**RE: Responses to Data Requests  
New England Clean Energy Connect Project  
Natural Resources Protection Act and Site Location of Development Act permit  
applications**

**Response to the  
November 20, 2017, and December 12, 2017  
MDEP Information Requests**

*New England Clean Energy Connect (NECEC)*

*Prepared for:*  
**Maine Department of Environmental Protection**

# PHOTOSIMULATION 11: KENNEBEC GORGE Looking North, Moxie Gore, 3 Structure Option

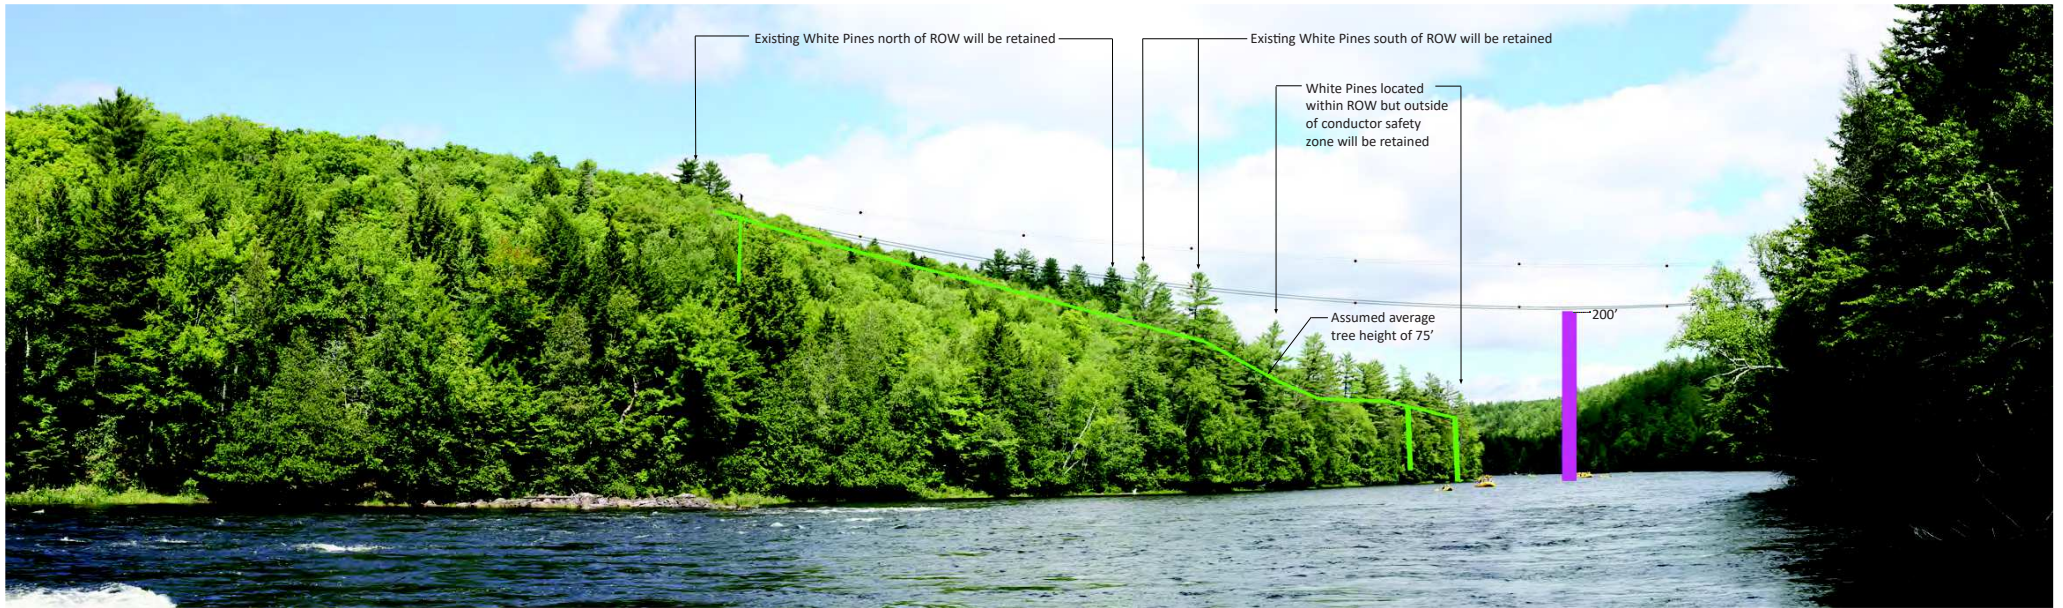
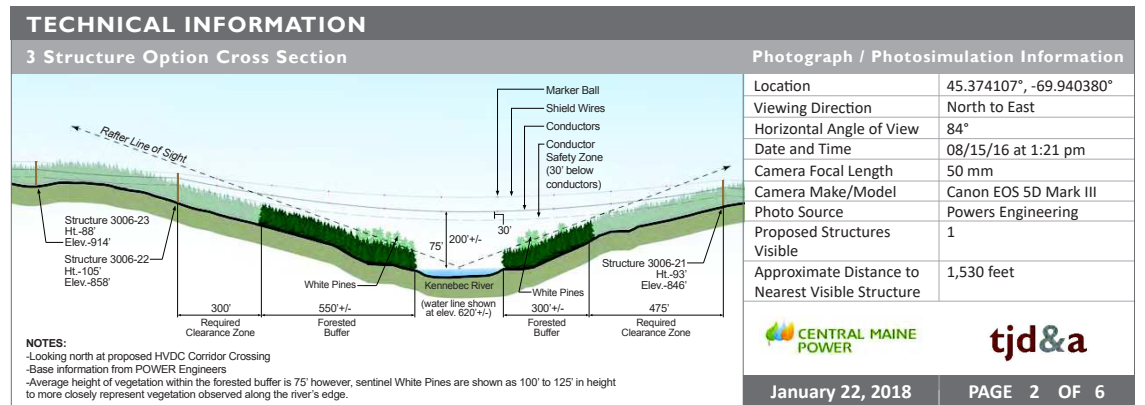
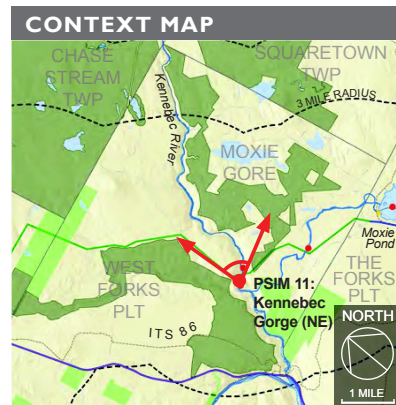
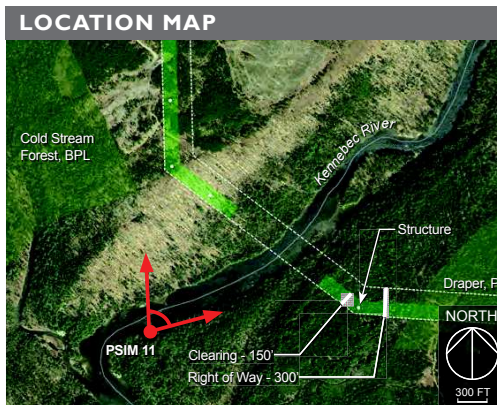
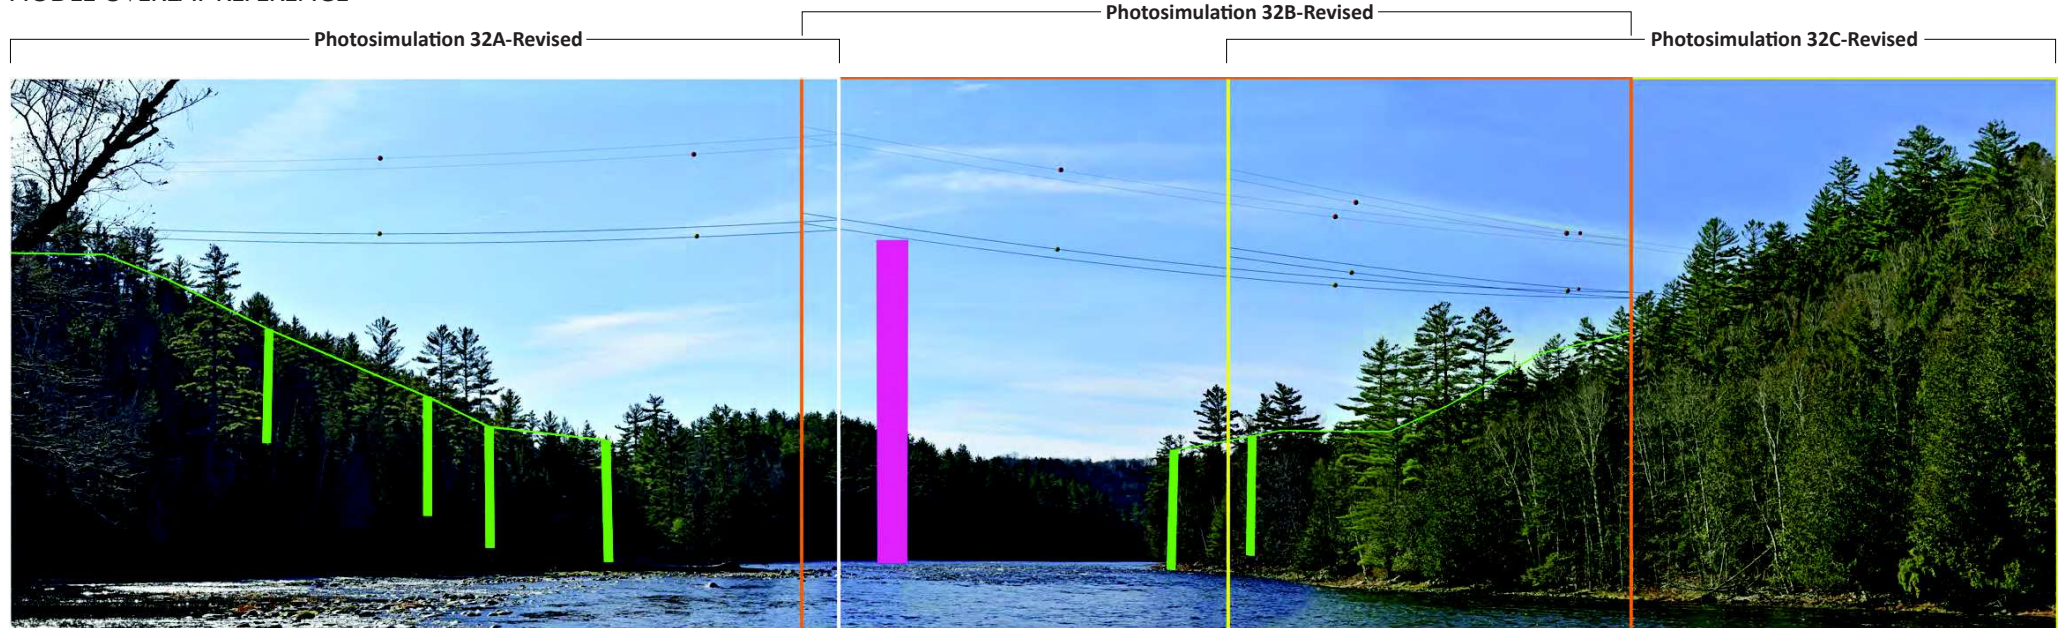
- 3. At the site visit on November 13, 2017 the applicant appeared to be working on a redesign of the crossing which would reduce the number of structures near the Kennebec River, elevate the conductors farther above the river, increase the undisturbed buffer along the river. Please provide the new design as soon as possible and include photosimulations which show the view looking directly into the corridor from the river. Also, quantify the vegetation that will need to be cut in the “buffer” area of the Gorge, both during construction and maintenance activities. The Department will need to have an understanding of the height of the conductors and the wire safety zone as well as the height of the capable vegetation that currently exists. If vegetation will be removed in this area (through maintenance activities) we need to evaluate that.**

In its NECEC Site Law application submitted on September 27, 2017, CMP proposed a five-structure configuration over the Kennebec River Gorge crossing. Based on the original cross section and photosimulation, three of the five structures would be within the line of sight of users on the river. A 150-foot wide forested buffer was proposed on the southeastern river bank and a 250-foot wide forested buffer was proposed on the northwestern river bank. The vertical distance from the lowest conductor to the river was 150 feet (+/-) at maximum sag based on this five-structure design.

CMP has since redesigned the Kennebec River Gorge crossing to increase and maximize the forested buffer on both sides of the river bank and to remove Structures 3006-21, 3006-22 and 3006-23 from the line of sight of users approaching the crossing point from upriver.

On the southeastern river bank approximately 300 feet of forested buffer will be maintained, with trees within this buffer at an average mature height of 75 feet. On the northwestern river bank approximately 550 feet of forested buffer will be maintained, with trees within this buffer also at an average mature height of 75 feet. At the centerline of the river, the conductor will be approximately 200 feet above the water level at maximum sag.

Individual trees within the two forested buffers that grow to heights which encroach into the conductor safety zone will be selectively cut and removed to maintain minimum required conductor clearance. Trees and vegetation which do not encroach into the conductor safety zone will not be cut. The conductor safety zone is depicted on the Kennebec River Gorge crossing cross-section and is approximately 30 feet below the lowest conductor at maximum sag.

Advantages of the proposed 3-Structure design compared to the 5-Structure design include: fewer structures; greater vertical clearance over water; greater vertical clearance over trees; retention of trees over a larger area of forested buffer; and screened views of the transmission line structures and the cleared corridor from the perspective of river users.

CMP provided revised photosimulations and cross sections depicting the 3-pole structure redesign in an email to MDEP on December 12, 2017. Upon further conversations with LUPC, CMP is providing (attached to this submittal) revised photosimulations, dated January 22, 2018, of the 3-pole structure redesign, at a “normal view,” removing the distortion and providing a more accurate depiction of the conductor sag over the river. Additionally, the mark-up of the panoramic photos includes overlaid scale references and additional detail of the low point of the conductor sag and the assumed average of the 75-foot existing tree height. See Attachment A: Kennebec River Gorge Photosimulations.

Figure 1. Typical Dewatering System

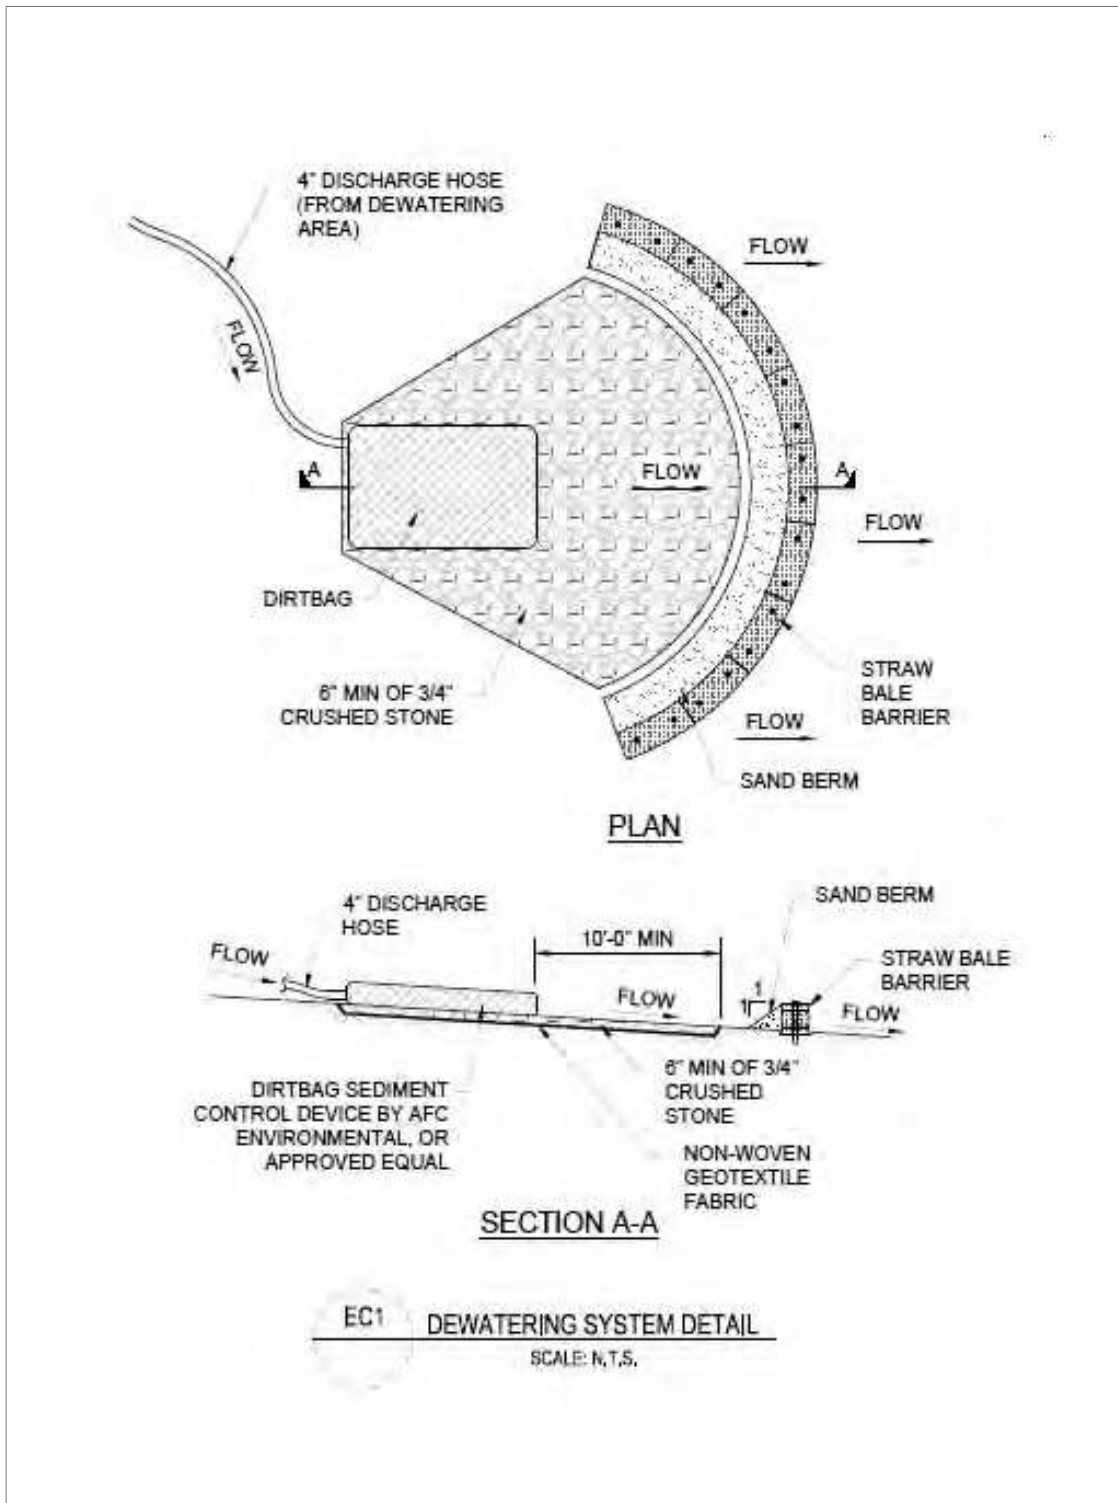
**12. The majority of the poles for the DC portion of the line are single-pole, self-weathering, structures that are approximately 100 feet tall. Will these structures be placed on a foundation or will they be placed in a drilled hole similar to other utility line structures? If they are to be placed on a foundation, please provide typical dimensions. Also, please provide typical dewatering plans for foundation holes, and site-specific plans for those structures within 75 feet of a protected natural resource.**

Dewatering will be performed in all excavations containing water prior to backfill or concrete pouring activities. It is important to note that site conditions across the project vary widely and not all excavations will contain water or require dewatering. Topography and soil characteristics, as well as seasonal and weather variations, are just a few variables that can affect the presence of water and the need for dewatering, thus making it impractical to develop site specific plans for dewatering prior to construction activities. In all cases when dewatering is necessary, it will be conducted in a manner that minimizes impacts to water resources to the fullest extent practicable and maintains compliance with permit conditions and water quality standards. Such dewatering details are outlined in the attached NECEC Project Construction Dewatering Plan (see Attachment C).
